Technical Service Information

CHRYSLER A604 UPDATED REPAIR PACKAGE

This bulletin applies to all Dynasty, New Yorker, Landau, Ram Van, Caravan, and Voyager vehicles.

Figure 1

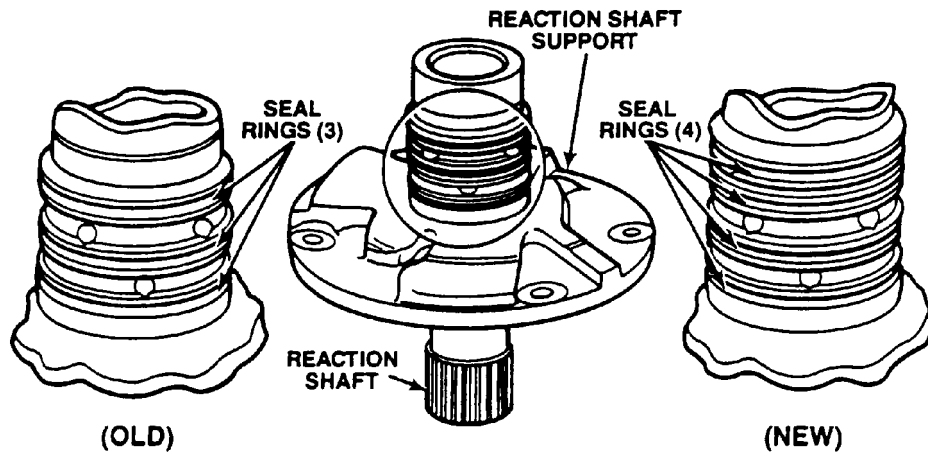
There is now available from OEM a new repair package, part number 4549248, that includes a new 4 ring front pump reaction shaft (See Figure 1), and a new input clutch hub with shallower "O" ring grooves to increase the compression of the "O" rings (See Figure 3). The new 4 ring front pump reaction shaft (Figure 1) provides better sealing for the overdrive clutch, and the new input clutch hub with shallower "O" ring grooves (Figure 3) provides better sealing for both the underdrive clutch and the reverse clutch. Both of these updated parts are highly recommended to provide better durability for the A604 transaxle.

Figure 2

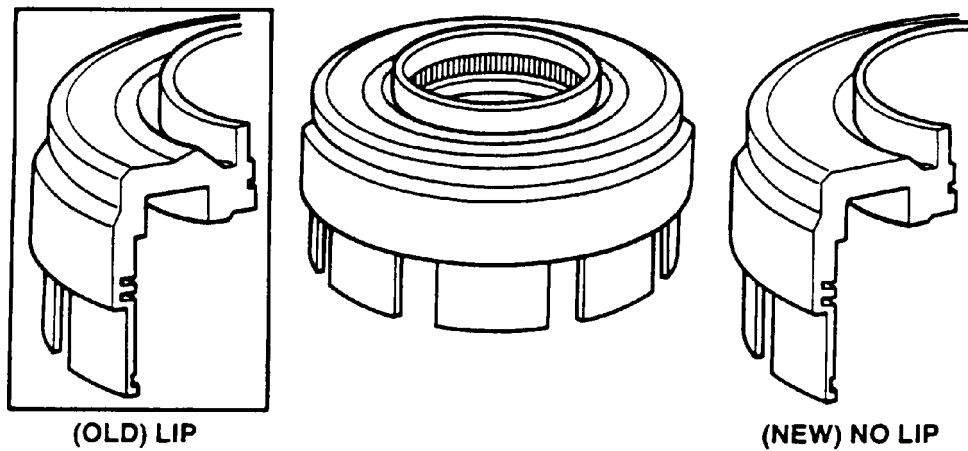
There has also been a modification to the input clutch retainer as shown in Figure 2. The "Lip" can be machined off of the old style input clutch retainer, or it must be replaced with part number 4431609. Refer to Figure 2.
